**STREETSBORO PLANNING AND ZONING COMMISSION**  
**Regular Meeting**  
**Tuesday April 13, 2021**  
**7:00 pm**

RE: Planter Sign Review- Speedway, 9254 SR 43

RE: Site Plan Amendment for City Park to Locate 2 Sand Volleyball Courts.

**LS-1**

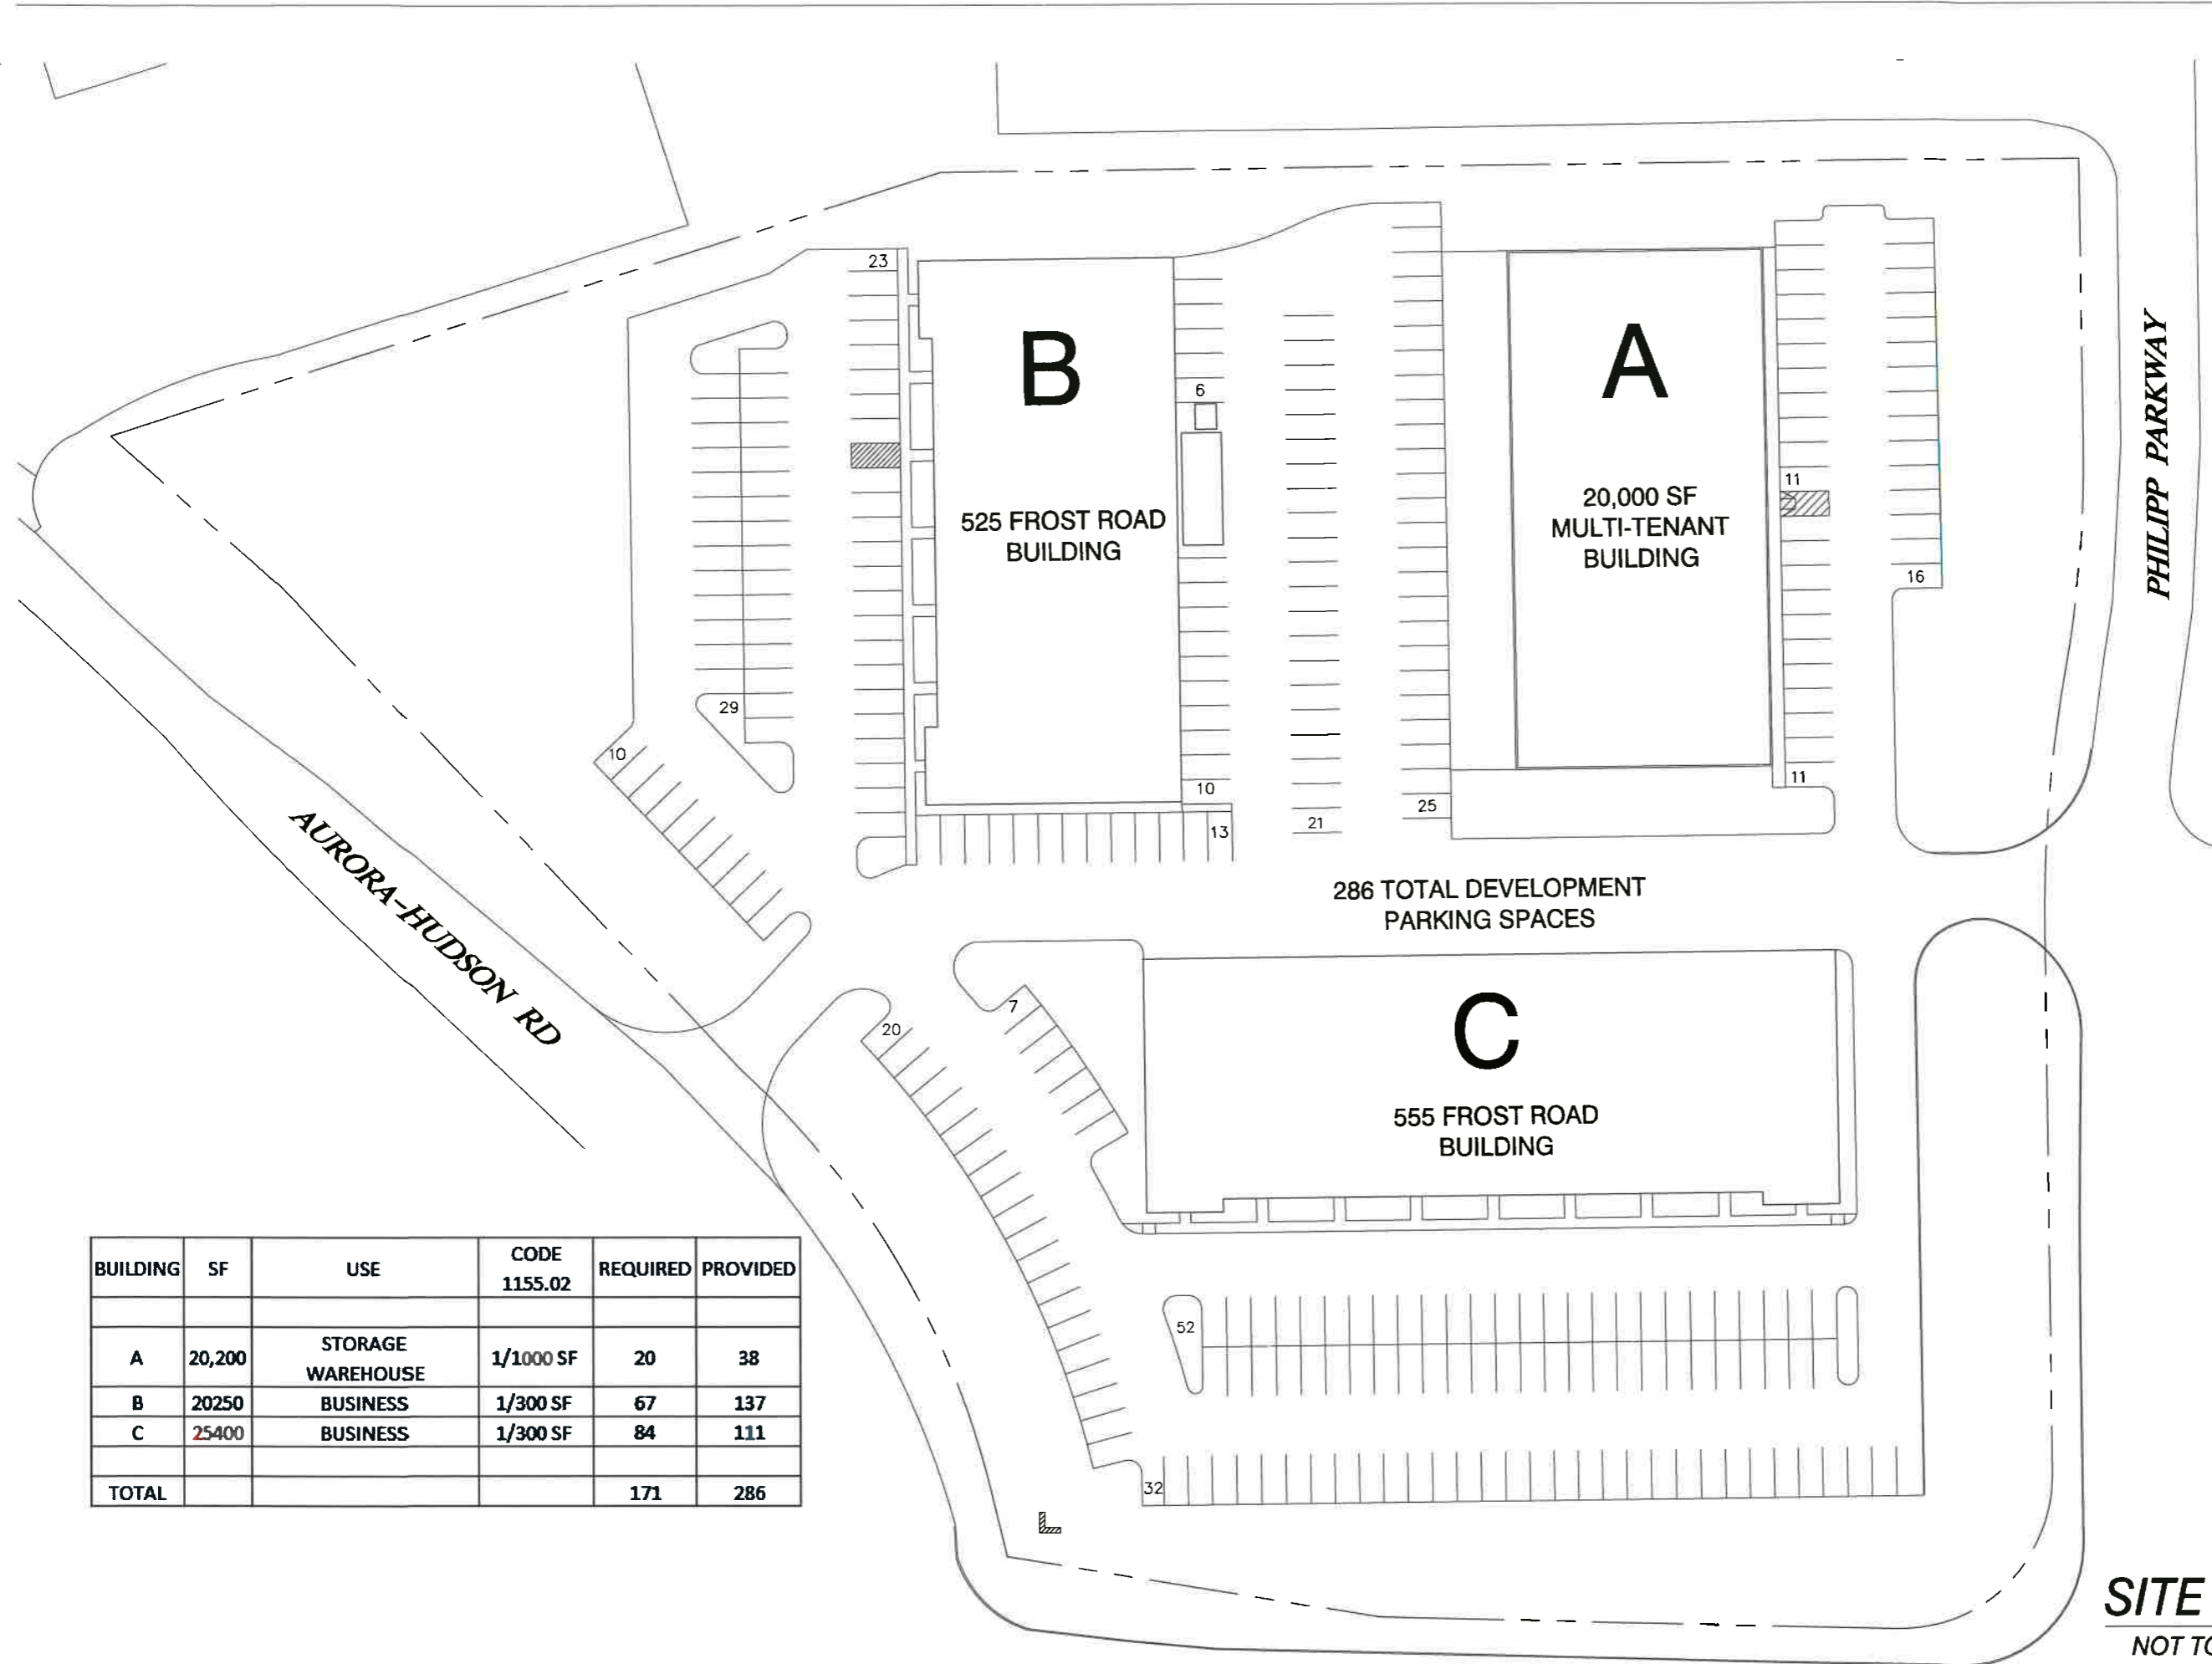
- f. *HVAC units.* Plans note a slightly sloped roof and site plans show no ground-mounted HVAC units for the proposed building. The applicant should clarify the location of proposed HVAC units and plans should be revised to show HVAC units and necessary screening. Staff will work with the applicant to adequately obscure HVAC units from view, while also allowing for proper access to the units for maintenance purposes.
5. Landscaping Plan (Sheet LS-1)

**E0**

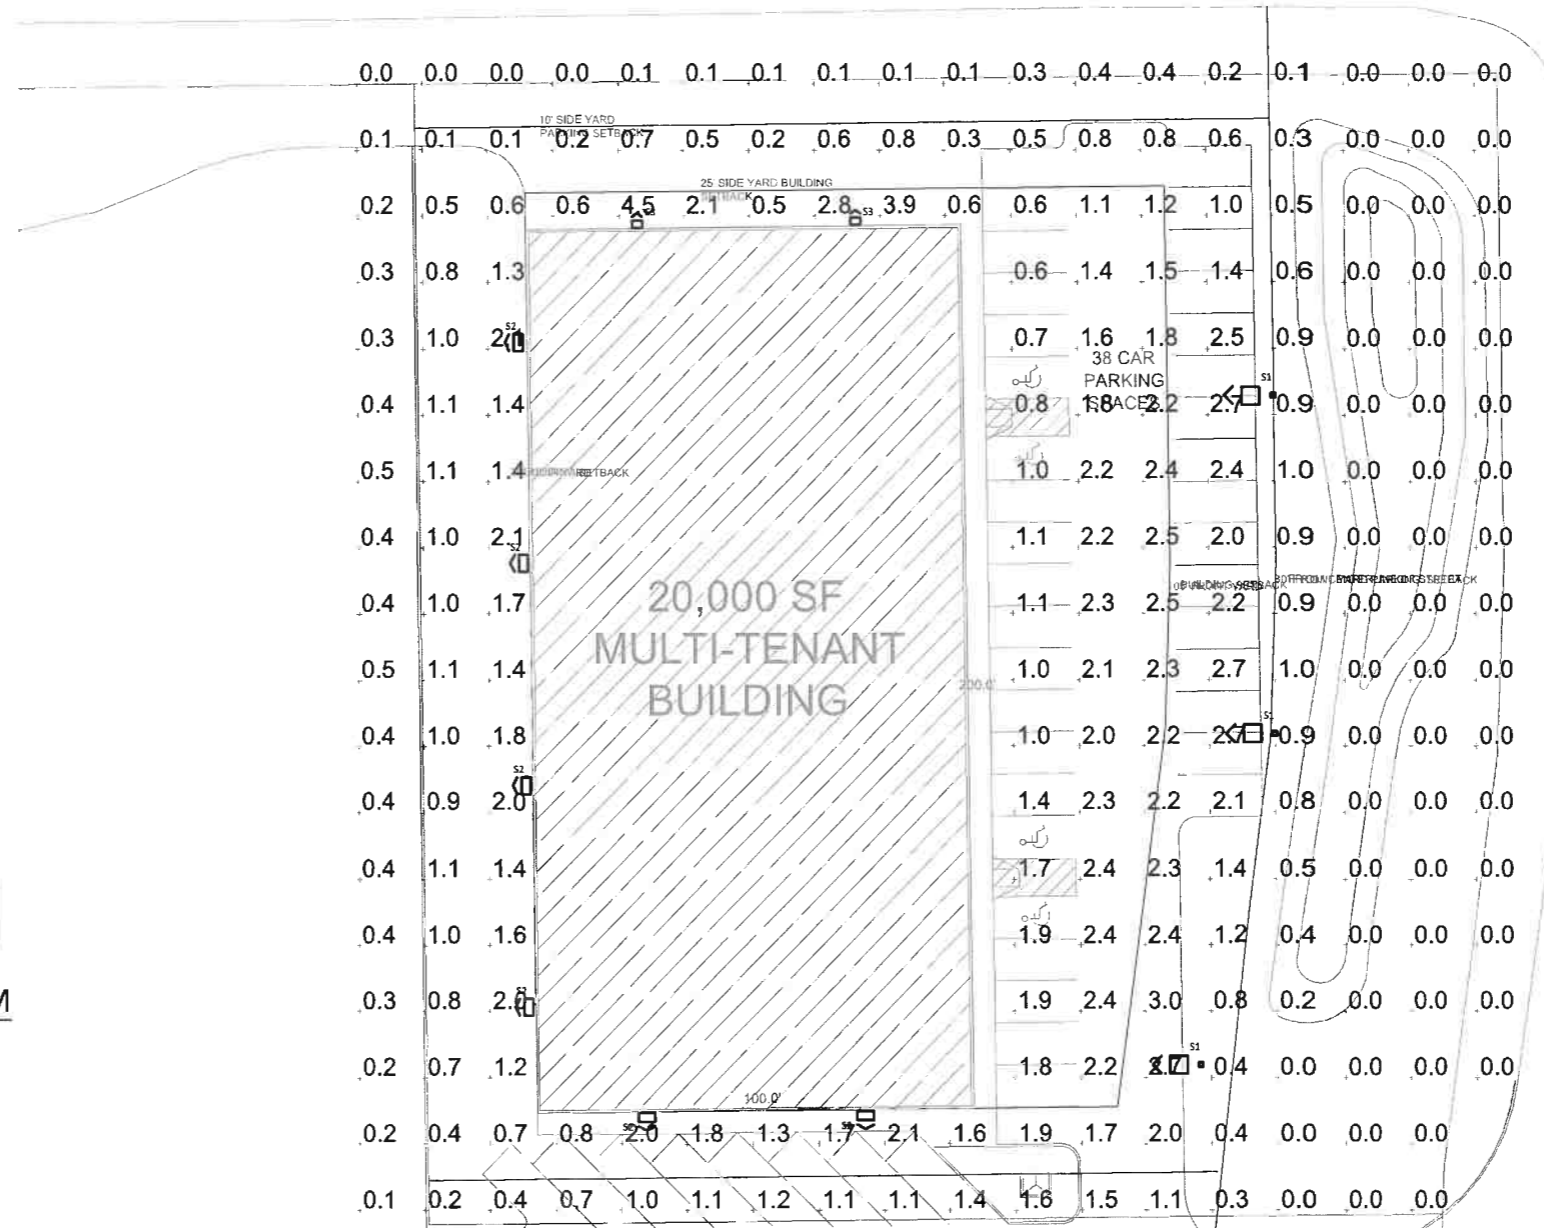
6. **Photometric Plan (Sheet E0).**
- a. *Luminaire Schedule- Quantity; Fixture Details.* Plans should be revised to show a site fixture schedule that includes the quantity, type (including fixture details), and mounting height of all proposed exterior light fixtures.
